Access Compliance Report

Public Rights-of-Way

Intersection ID: 5097	Main Street: CARDINGTON_CT	Cross Street: PENNYCROSS_LN	Location: SE
ADA ID: 997E0D335EAB	Ramp Type: Perp	Initial Pass/Fail: Fail	Overall Compliance: No
Severity Score: 13.75			
Codes/Mitigation Info/Possible Solution		Field Measurements/Component Compliance

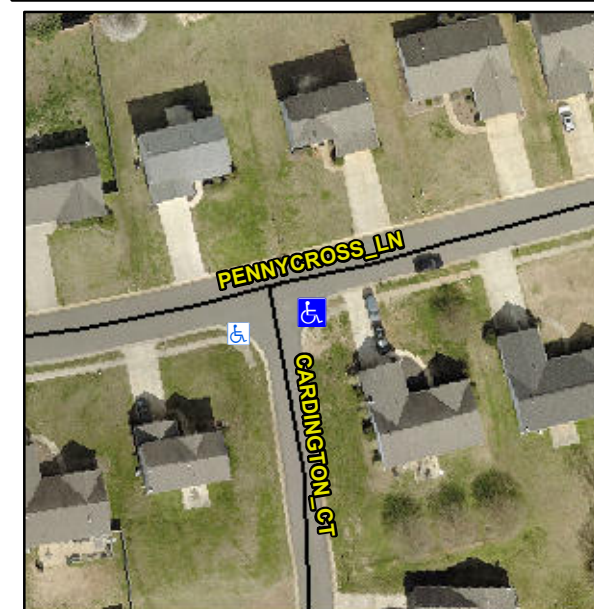
Not Found, R304.2.2, R304.5.3

Compliance	Description	Data	Compliance	Description	Data
N/A	Ramp Length (in)	81.0	No	Ramp Slope (%)	9.2
Yes	Ramp Width (in)	48.0	No	Ramp XSlope (%)	3.1
N/A	Flare Type LT	N/A	N/A	Flare Type RT	N/A
N/A	Flare Slope LT (%)	N/A	N/A	Flare Slope RT (%)	N/A
N/A	Flare Traversable LT?	N/A	N/A	Flare Traversable RT?	N/A
N/A	Landing Length (in)	N/A	N/A	DWS Provided?	N/A
N/A	Landing Width (in)	N/A	N/A	DWS Contrast?	N/A
N/A	Landing Slope (%)	N/A	N/A	DWS Length (in)	N/A
N/A	Landing X Slope (%)	N/A	N/A	DWS Full Width?	N/A
N/A	Landing Curb? (Y/N)	N/A	N/A	DWS Offset (in)	N/A
N/A	Shared Landing?	N/A			
N/A	Gutter Ponding?	N/A	N/A	Gutter Slope (%)	N/A
N/A	Gutter Lip Ht (in)	N/A	N/A	Gutter X Slope (%)	N/A
N/A	Painted X Walk1?	No	N/A	Painted X Walk2?	N/A
	X Walk 1 Direction	To W		X Walk 2 Direction	N/A
N/A	X Walk 1 Width (in)	N/A	N/A	X Walk 2 Width (in)	N/A
	X Walk 1 Slope (%)	1.7		X Walk 2 Slope (%)	N/A
	X Walk 1 X Slope (%)	4.5		X Walk 2 X Slope (%)	N/A

Remove & Replace Entire Ramp.
